Project		Proposed Burghfield Footway	
Drawing title		Northern Section	
Drawn by	Date	Dwg size	Revision
DW	Feb 09	A1	1
Authorised by	Scale		
JW	1:500		
Drawing Number	81375/PF1

MEMORANDUM

Land at AWE Burghfield
Application 08/02287/COMIND
Proposed 26,573 sqm of light industrial building

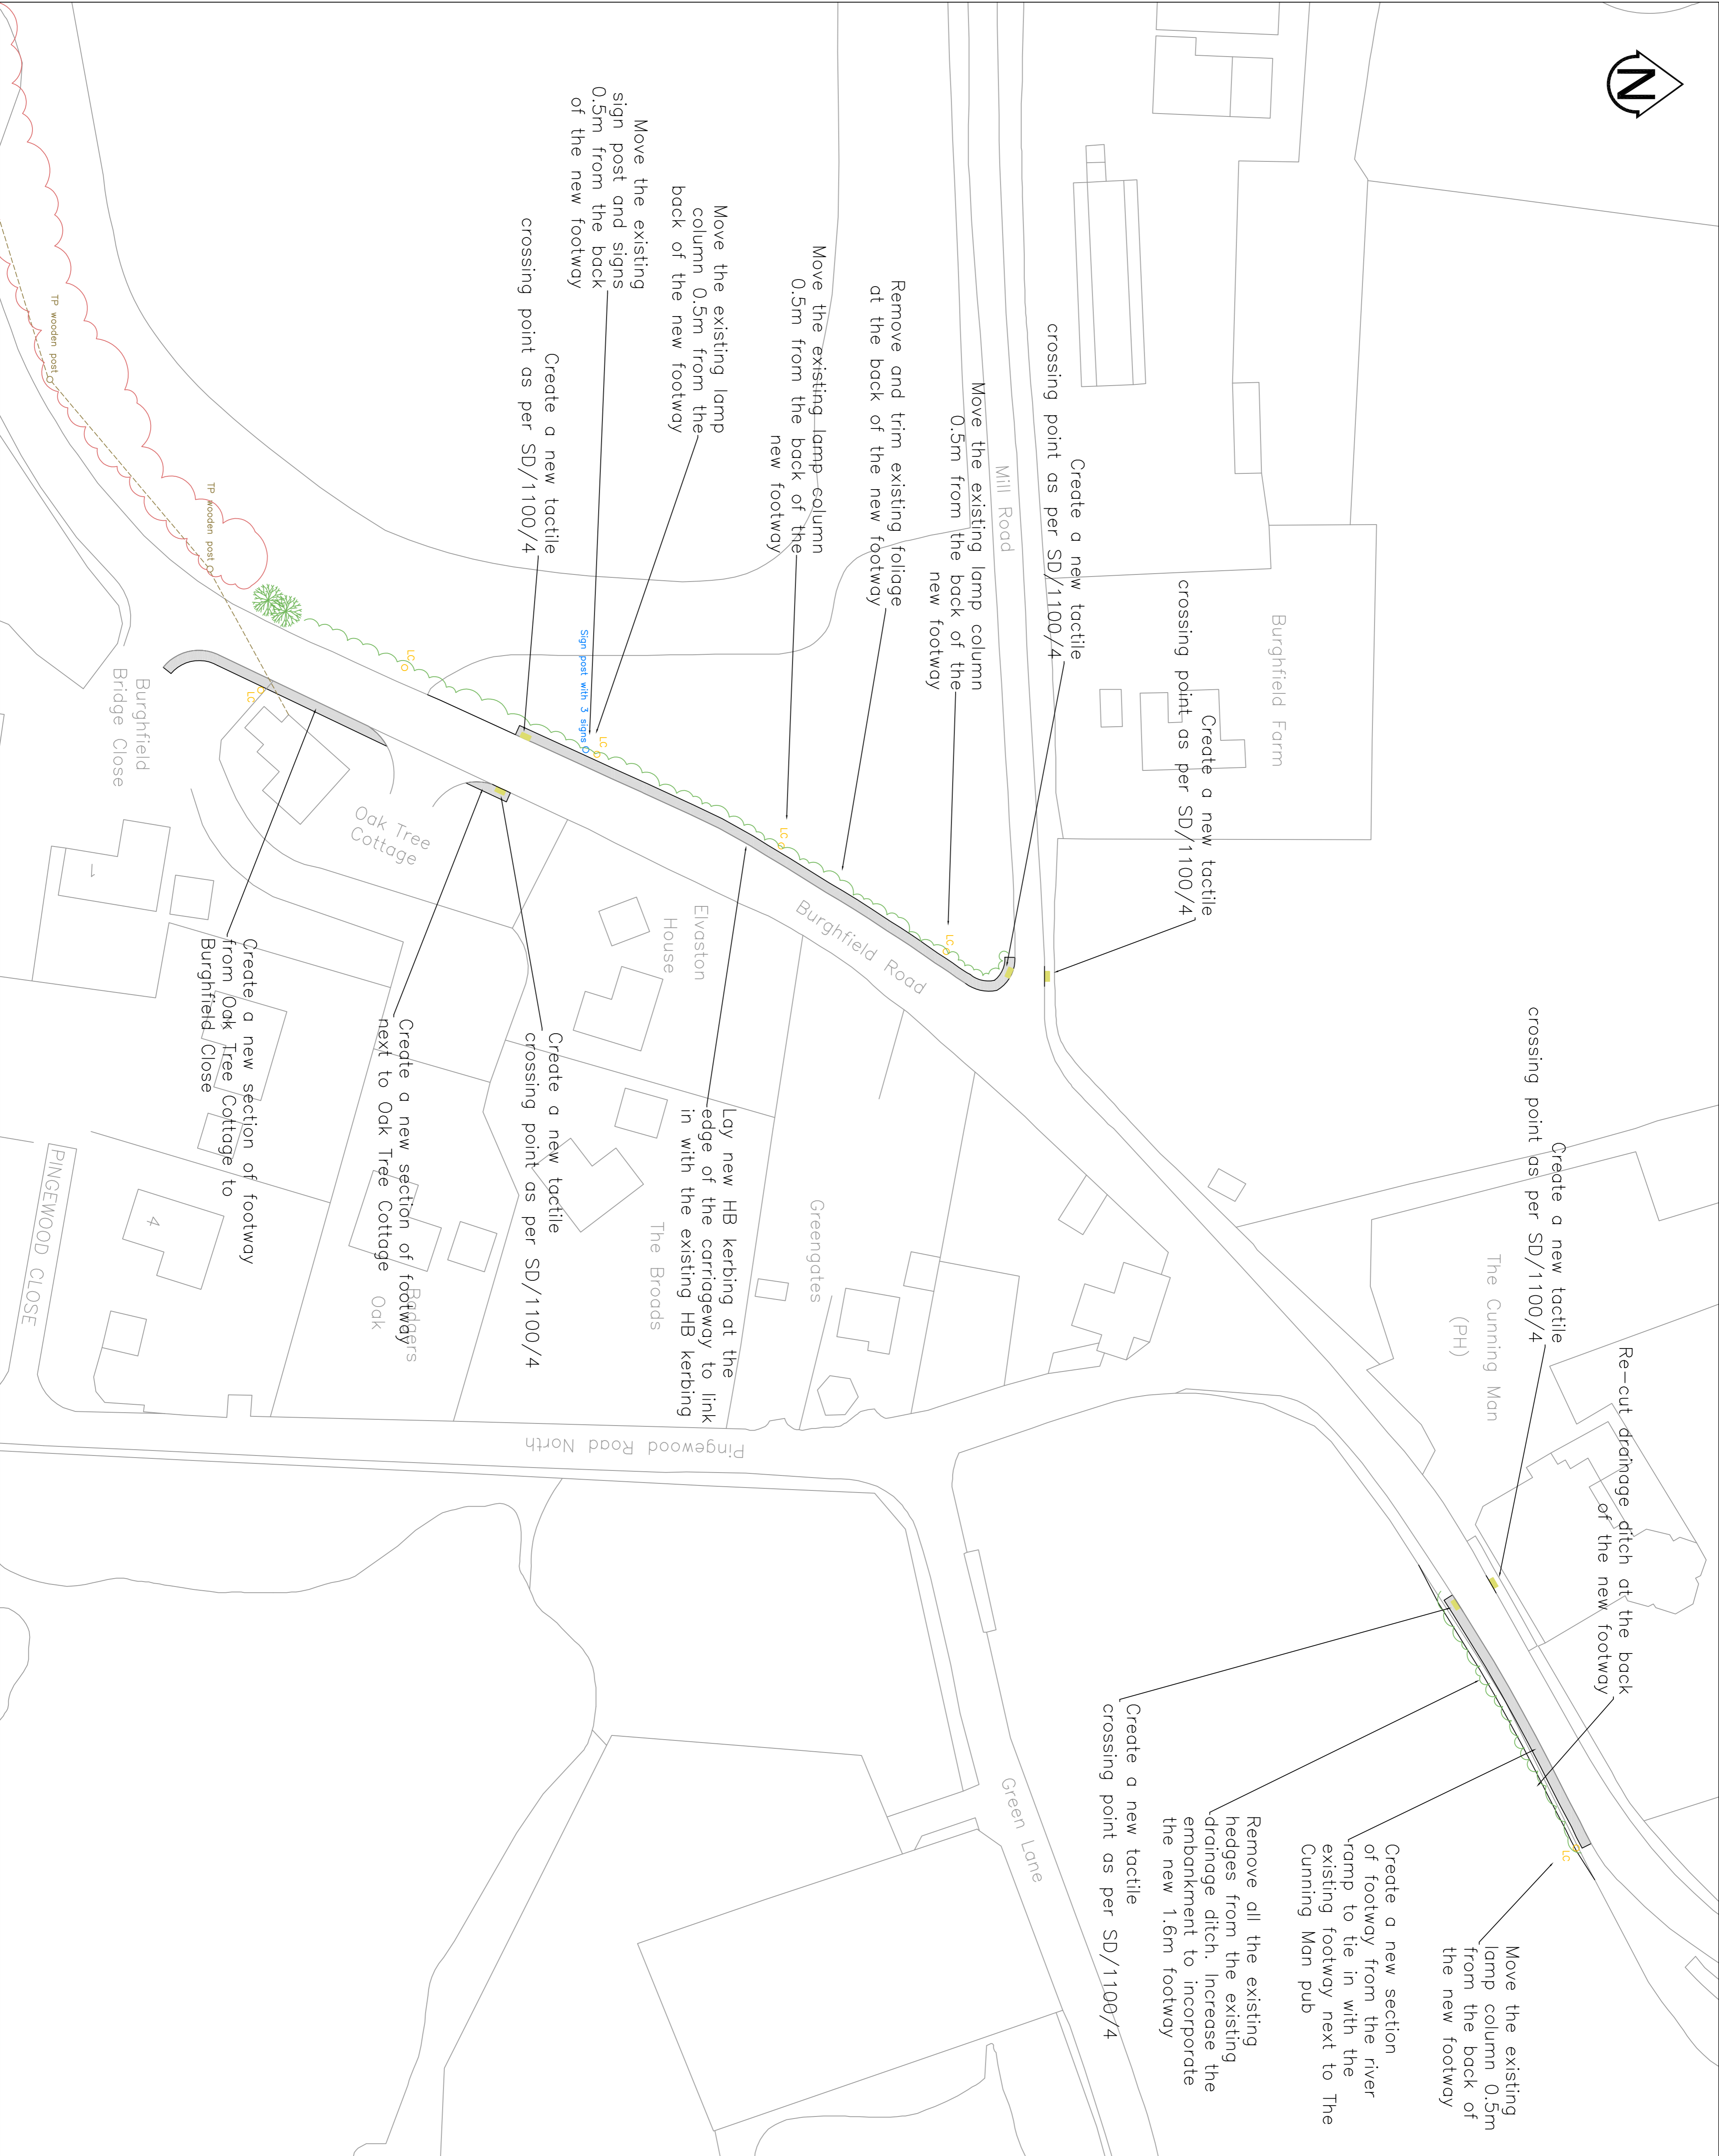
8. I attach a draft plan produced by the Projects Team for the provision of sections of footway linking Burghfield Bridge Close to the Cuning Man PH. The extent of the footways denotes the available funding, and I have been informed that these works will be provided during the summer of 2009. RPS will need to ensure that their proposal ties in and liaison with Principal Engineer Jon Winstanley on 519 087 will be required.
